Fast Toggled Exposure Mode

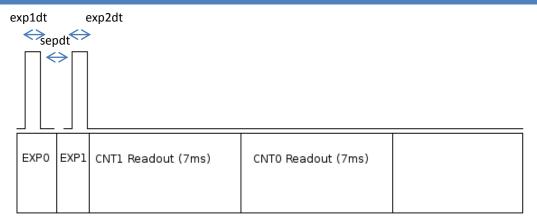
```
Original "Start Acquisition" TCP Command (EPICS->PiXirad-1 Detector): "DAQ:! LOOP nframes shwidth dlywidth romode trgmode trsfmode biasmode\n" romode option list will be enhanced with "FTE" -> {"1COL0", "1COL1", "2COL", "DTF", "FTE"}
```

New TCP Command (EPICS->PiXirad-1 Detector) will be added to manage delays:

```
"DAQ:! SET_FTE_CONF cycles exp1dt exp2dt sepdt"
```

cycles: unsigned integer how many times the EXPO,EXP1 sequence

must be repeated (>1 means "accumulate");

exp1dt: float (us);
exp2dt: float (us);
sepdt: float(us);

The only difference is that, when "FTE" mode is selected every frame acquisition needs cycles * 2 pulses at "Sync-in";
